Subject: Mixed-use precinct, including in-fill affordable housing, at Crescent Parklands, Holroyd
Property: 1 Crescent Street Holroyd NSW 2142
Proposal: SSD Application for Affordable Housing at 1 Crescent Street, Holroyd - Crescent Parklands (SSD-70283710)

SSD Application for Affordable Housing at 1 Crescent Street, Holroyd, known as Crescent Parklands (SSD-70283710) – Detailed Comments from Cumberland City Council

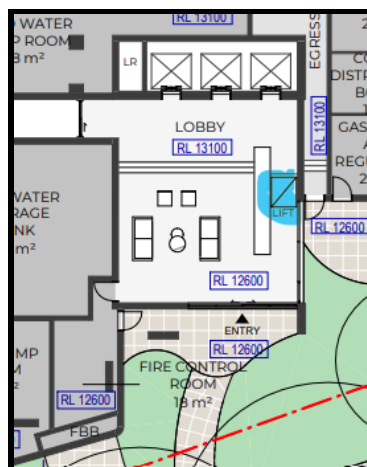
The lobby servicing building 7 provides a 'lift' refer to blue highlight below. It is unclear if this is a chair lift and if a ramp is also provided to access the 'lobby' area. The use of 'chair lifts' are generally not supported and the Department should consider alternatives such as an access ramp to allow access for people with a disability.

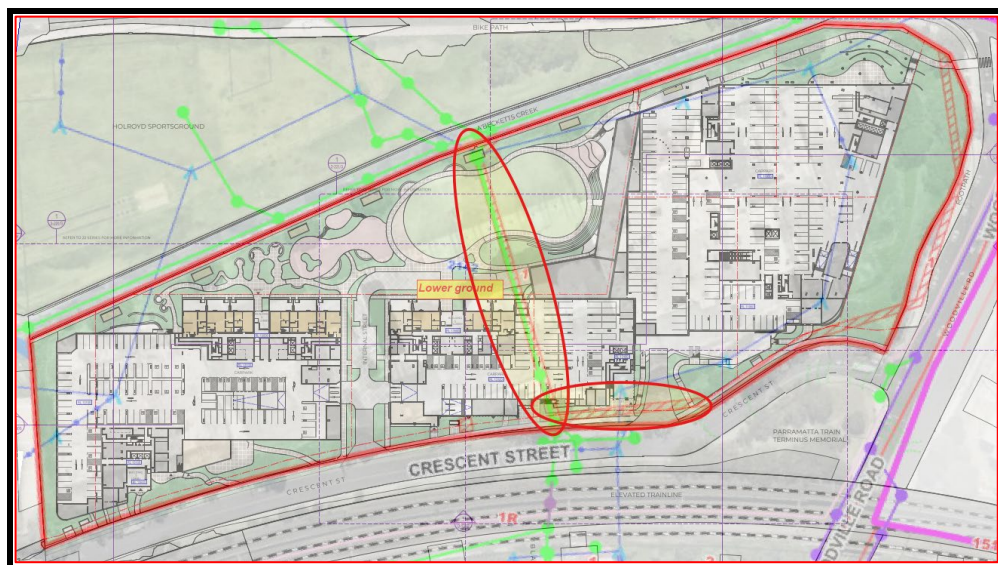
The buildings (building 4, 5, and the parking area under the central block (phase 2) are proposed over the existing drainage easement and stormwater pipe/conduit that runs across the subject site. The encroachments into the drainage easement and construction over the existing stormwater pipeline is not supported. The structure must be clear of the Council's drainage infrastructure.
